TVA-SQN-TS-06-03

**SEQUOYAH NUCLEAR PLANT (SQN) - UNITS 1 AND 2 - TECHNICAL
SPECIFICATIONS (TS) CHANGE 06-03 "ULTIMATE HEAT SINK (UHS)
TEMPERATURE INCREASE AND ELEVATION CHANGES"**

ENCLOSURE 1

TENNESSEE VALLEY AUTHORITY (TVA) SEQUOYAH NUCLEAR PLANT (SQN) UNITS 1 AND 2

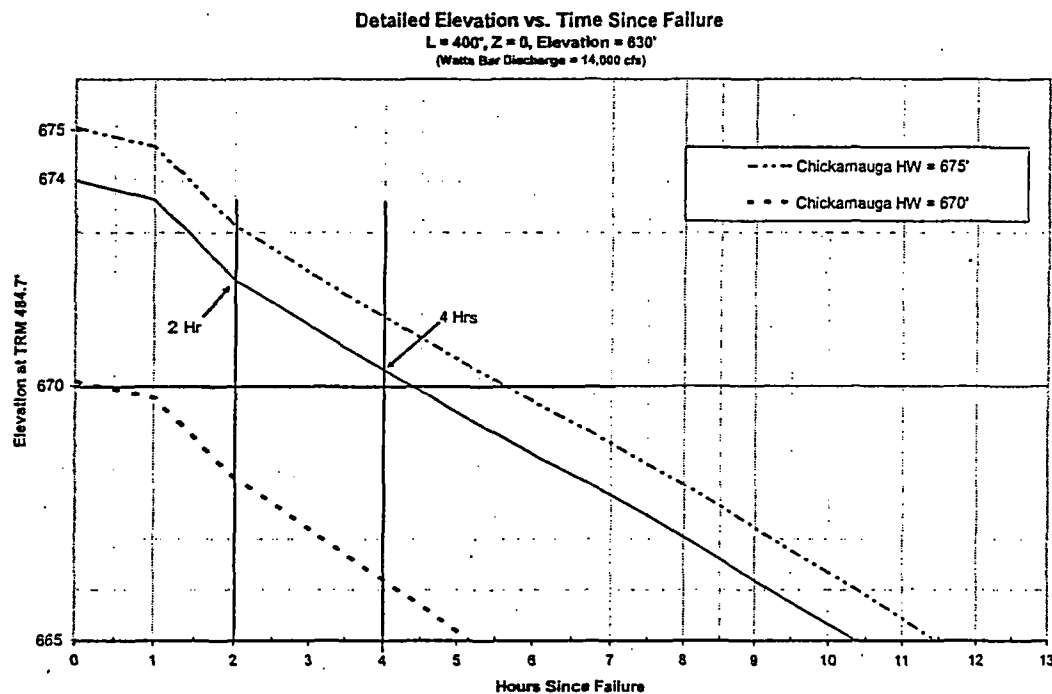
TVA has reviewed the recent ERCW flow balance and flow modeling (performance data). The review concludes that the components flow balanced at a river elevation of 670 feet are capable of supplying cooling water flow to support both short-term and long-term cooling needs following a LOCA and LODD. Also, a lower river level can supply the required minimum safety-related flows to the CCS and CS system heat exchangers without loss of net positive suction head; however, less operating margin exists which impacts operating fouling factors and requires removing equipment from service more frequently for flushing and biocide injections. TVA proposes a minimum river level of 674 feet for this UHS change request. An UHS elevation of 674 feet is conservative at 87°F, with regards to current analyzes and equipment performance data, to support essential heat loads following the accident events and provides at least 4 hours of river level above 670 feet following a LODD event (References 6 and 7). The below figure shows the river elevation change after the LODD. These

results are from Reference 8 with an overlay drawn-down curve for a river elevation starting point of 674 feet. A provision of 4 hours above the 670-foot system flow balance is adequate for compliance with the TS action statement, where the plant would be placed into Hot Standby (Mode 3) and in Cold Shutdown (Mode 5) within the following 30 hours, because lower river levels can supply the required minimum safety-related flow rates.
